RE: Field Office Application for Change
Water Right, File No. 15465

DWR FIELD OFFICE APPLICATION FOR APPROVAL TO CHANGE THE PLACE OF USE AND/OR THE POINT OF DIVERSION

Theis evaluation of proposed change in point of diversion, File No. 15,465

RE: Application for Change in Point of Diversion
Water Right, File Nos. 15465

Evaluation of proposed move for Water Right No. 15465

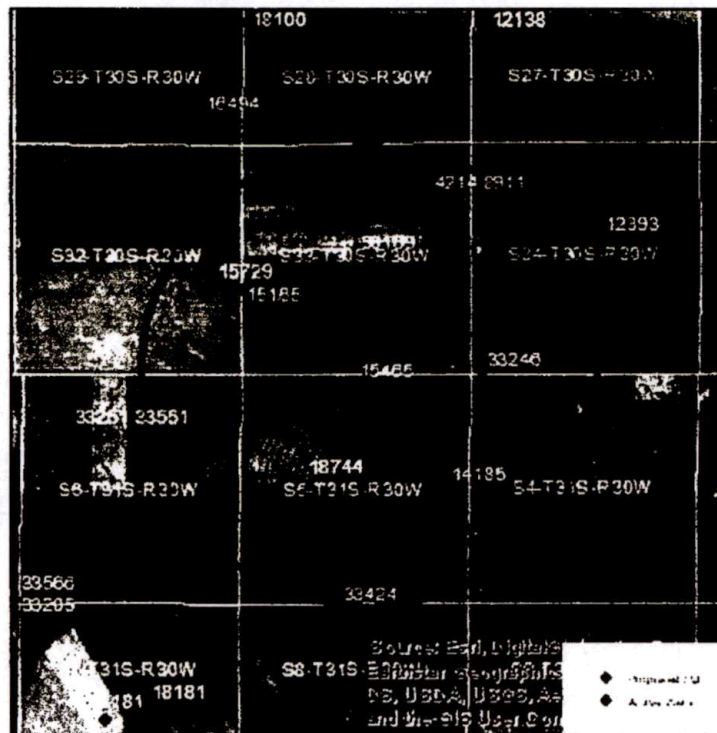
Proposed: Move water right no. 15465 to a new well location, 454 ft to the northeast.

Wells within 1 mile: 15165 & 15729, 30169, 4214 & 8911, 18744, 14185, and 33246.

The saturated thickness at the proposed well location is estimated to be 172 ft, based upon the GMD3 model. For saturated thickness between than 150 ft and 200 ft, the drawdown allowance is 3.5 ft.

Net drawdown exceeds the drawdown allowance for the wells authorized under water right nos. 15165 & 15729, 30169, 18744, 14185, and 33246. Critical well analysis was performed for those wells.

WELL TEST ANALYSIS

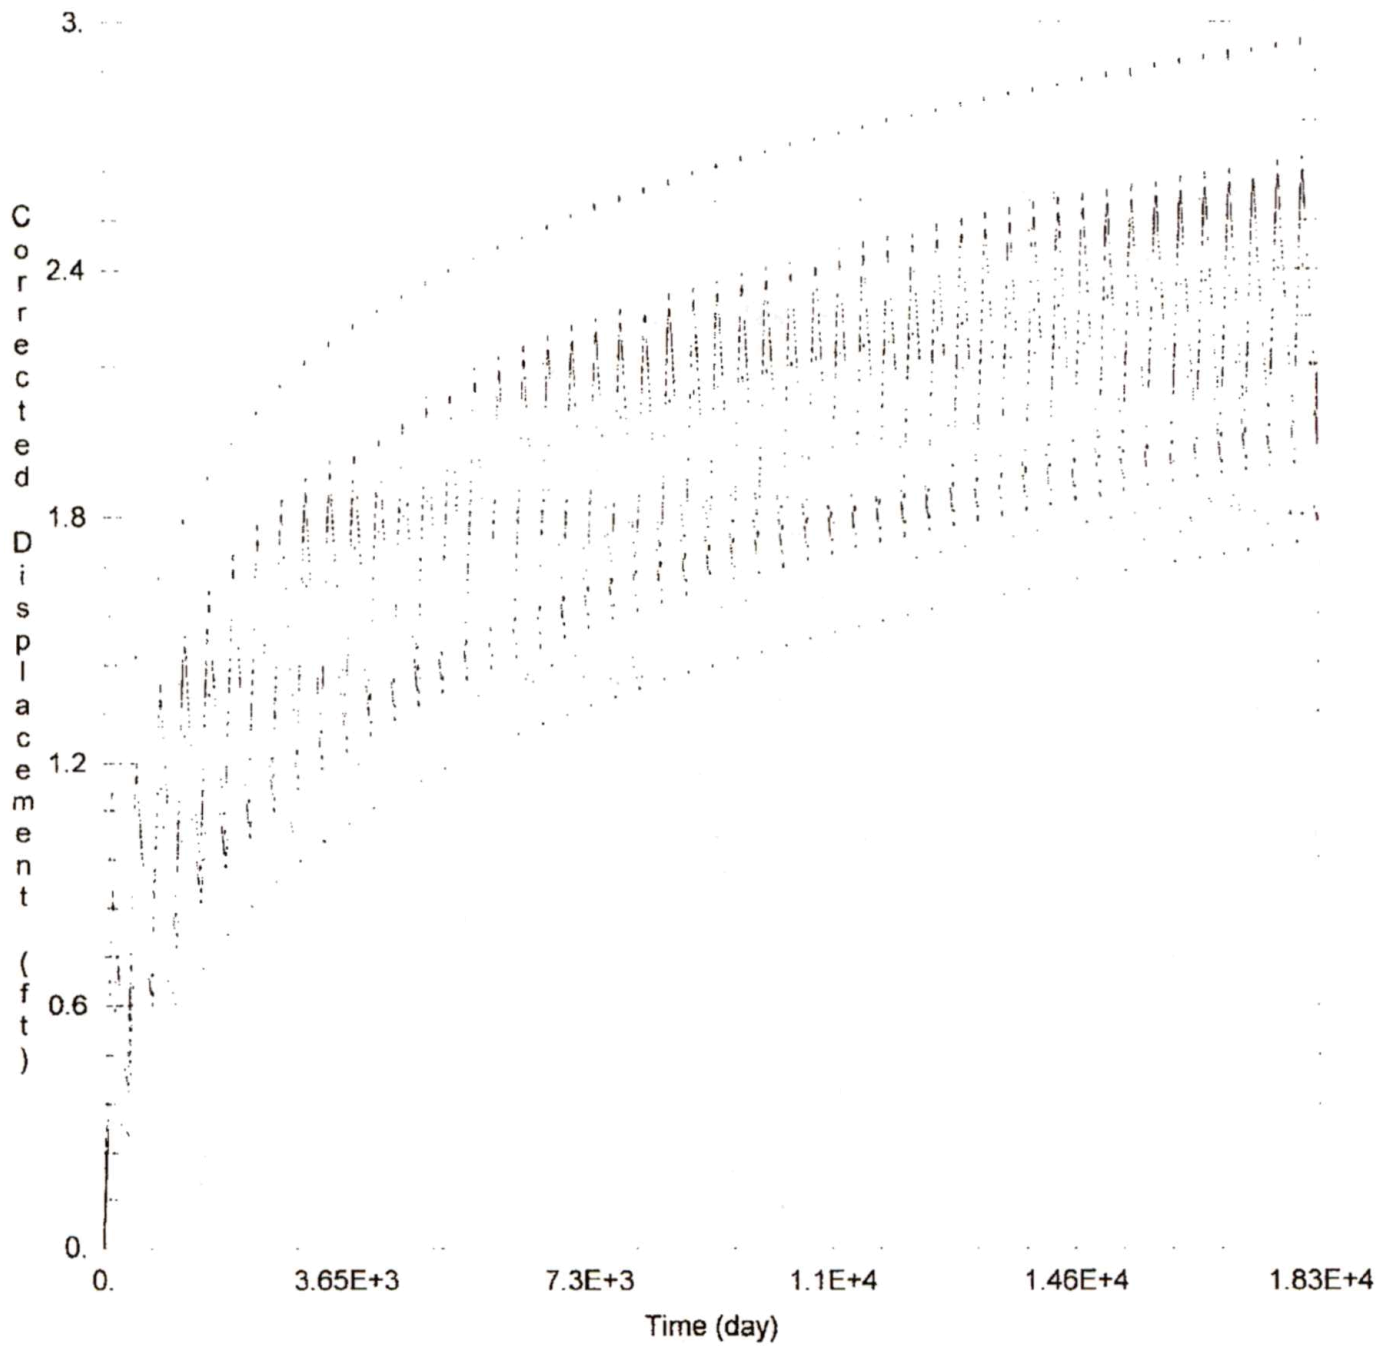
The proposed move is in an area with more than 170 ft of remaining saturated thickness, but projected aquifer declines exceed 2 ft/year. The analysis shows that net well-to-well effects created by this proposal are likely to be small but noticeable. Nearby wells were flagged as critical because projected aquifer declines over the next 25 years amount to more than 40% of the remaining saturated thickness after accounting for the well drawdown necessary to provide for current water use. Concerned neighbors should contact GMD3 at (620) 275-7147 or the Division of Water Resources at (620) 276-2901.
